FINAL PLAT
SUBDIVISION REPORT

SUBDIVISION COMMITTEE
METROPOLITAN AREA
PLANNING COMMISSION

S/D NO. 77-106 Name MESSIAH BAPTIST CHURCH SECOND ADDITION
Date Application Rec'd. 8-16-77 Preliminary Approval N/A
Scheduled S/D Meeting 8-25-77

MESSIAH BAPTIST CHURCH
2ND ADDN.

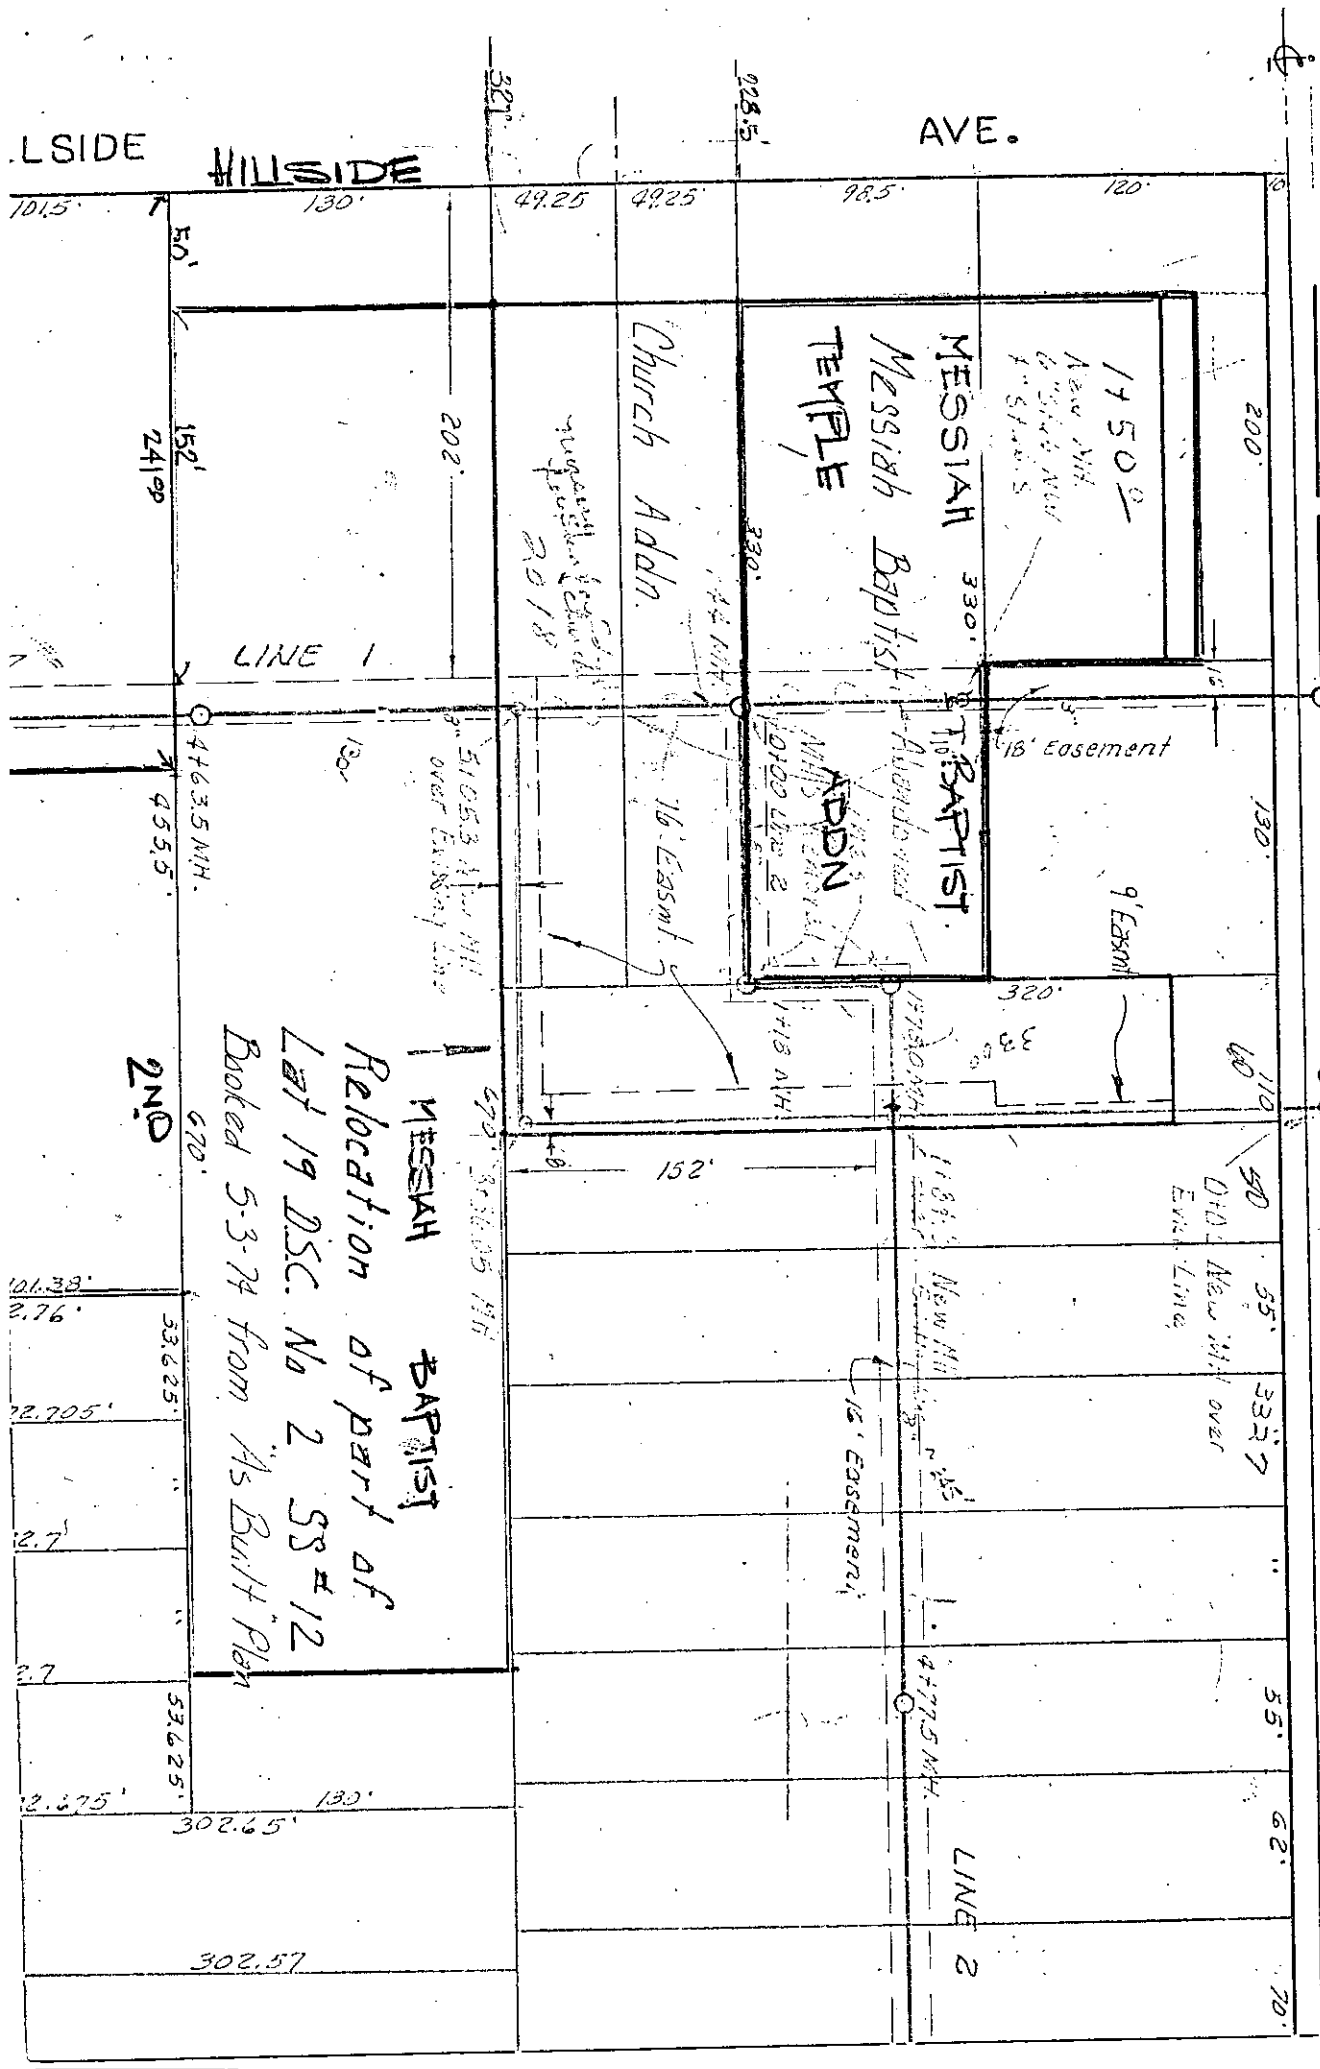
- A. "Access control except for one opening" shall be labeled adjacent to Hillside and the appropriate language included in the plat's text.
- B. A 25-foot building setback line from Hillside shall be shown on the face of the plat.

- C. The applicant shall guarantee construction of a 4-foot sidewalk on the east side of Hillside adjacent to subject property. The applicant shall be advised that sidewalk construction will be a requirement included in any building permit issued for this site.

- D. The applicant's engineer shall submit a lot grading plan to M. S. Mitchell of the Maintenance-Flood Control Office. A letter obtained from Mr. Mitchell approving said plan shall be submitted to the Planning Department.

- E. The 16-foot easement labeled on the plat by condemnation case number shall also be labeled as a sewer easement or utility easement, whichever the case may be.

REV A	4-15-77	DPJ	REVISED DRAINAGE PLAN
MESSIAH BAPTIST CHURCH			
CAMPBELL & CASTLE ENGINEERS WICHITA KANSAS			
DATE	August	1977	
WICHITA, KANSAS			DWG FILE NO
MESSIAH BAPTIST CHURCH Second Avenue			7745-B-5002d
SHEET NO 1 OF 1			DATE

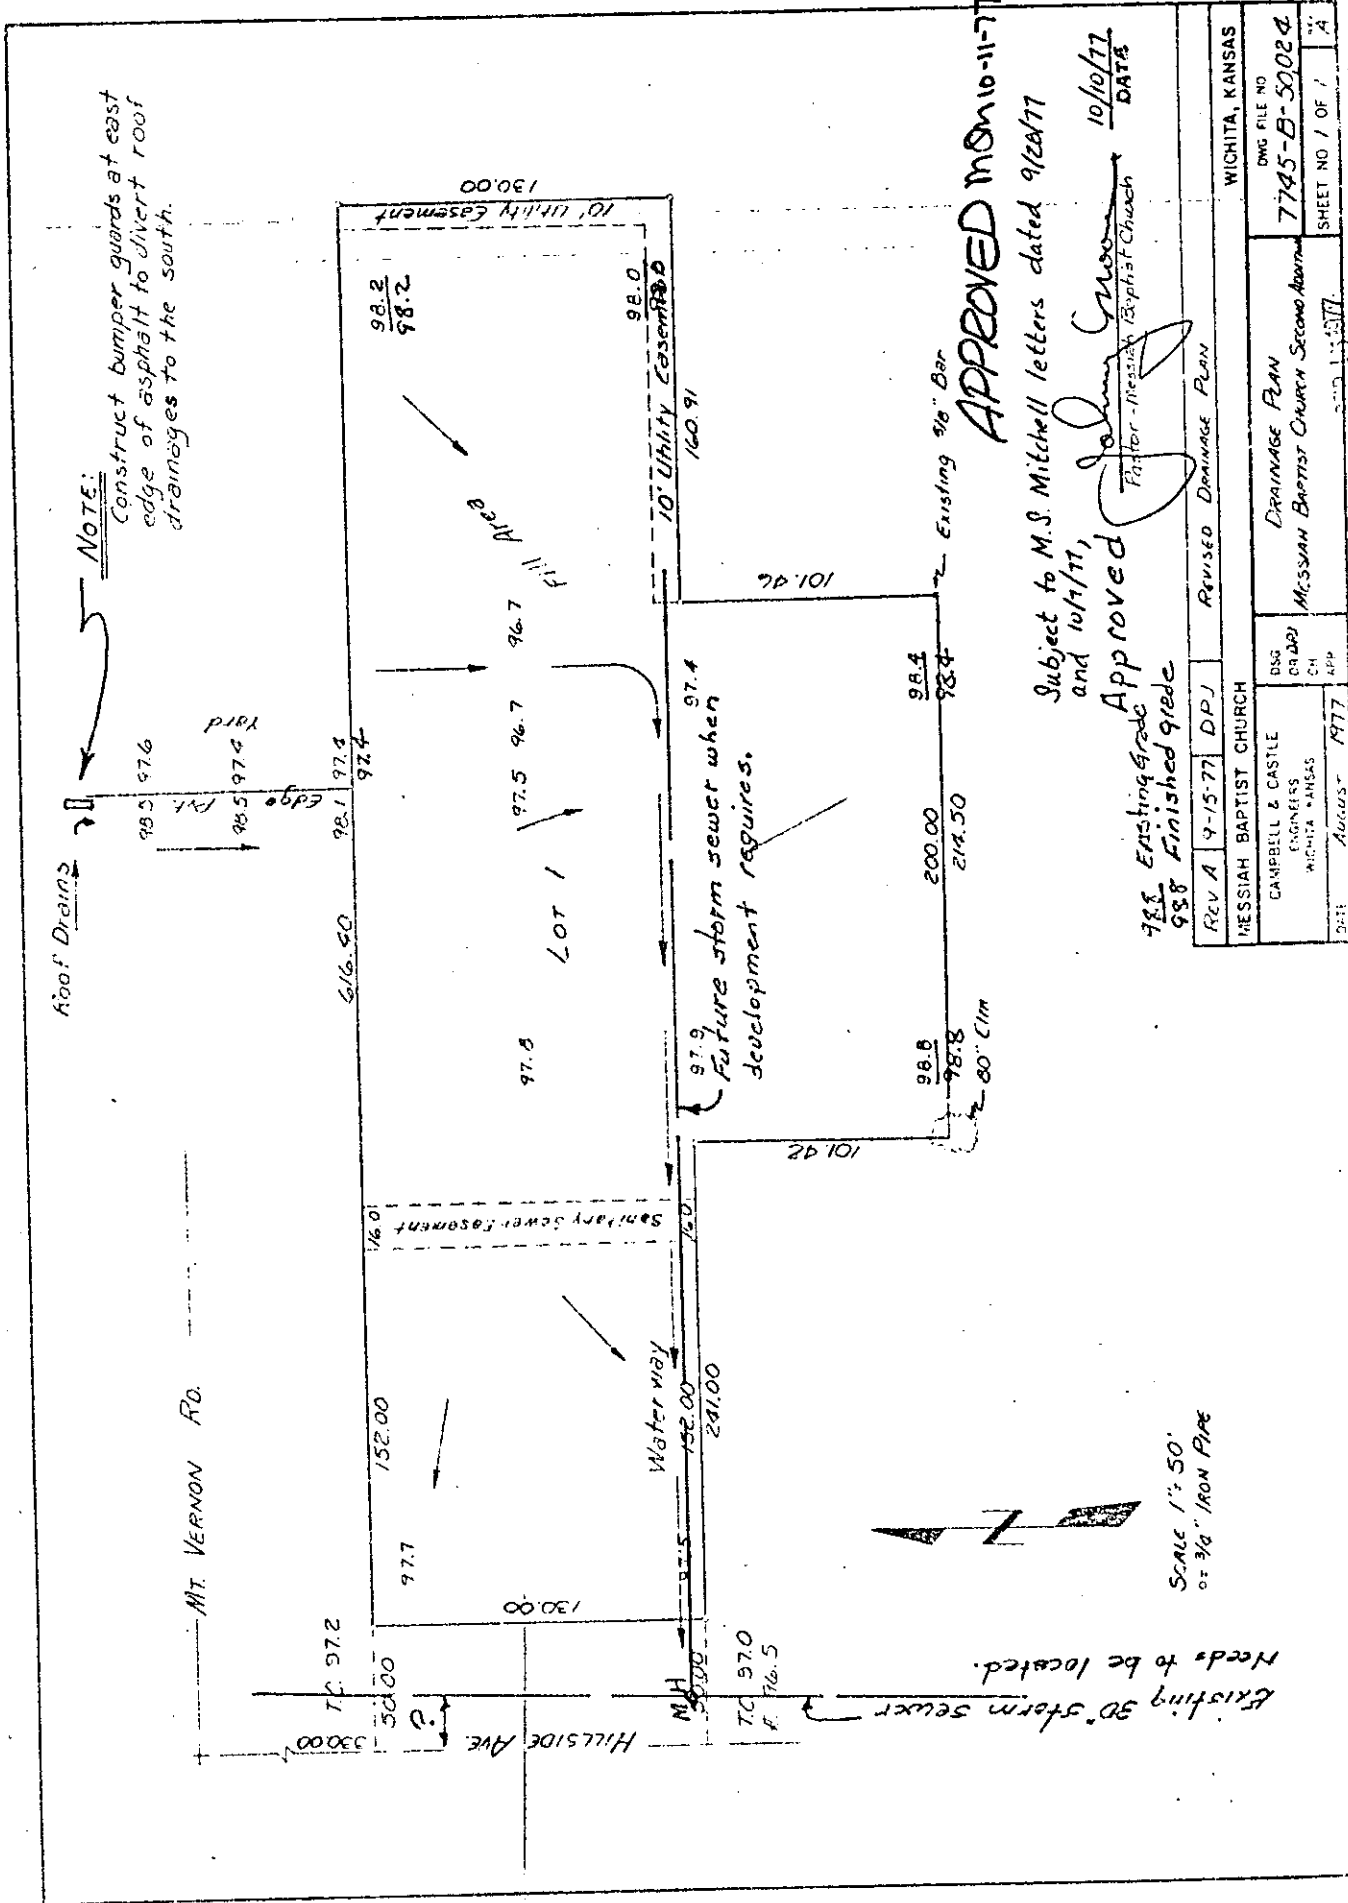
Construct bumper guards at east edge of asphalt to divert roof drainages to the south.

Existing 30" storm sewer Needs to be located.

It had been brought to our attention that the site development on the subject lot does not conform to the approved drainage plan which calls for storm water sewer extension from Hillside, as submitted at the time of platting.

Attached is a copy of the approved drainage plan. Any future building permit or site grading permit should not be issued until this situation is remedied. The eastern portion of this lot should not be permitted to fill which will cause further ponding of water to the property to the east.

Subject to M.S. Mitchell letters dated 9/26/77 and 10/17/77,
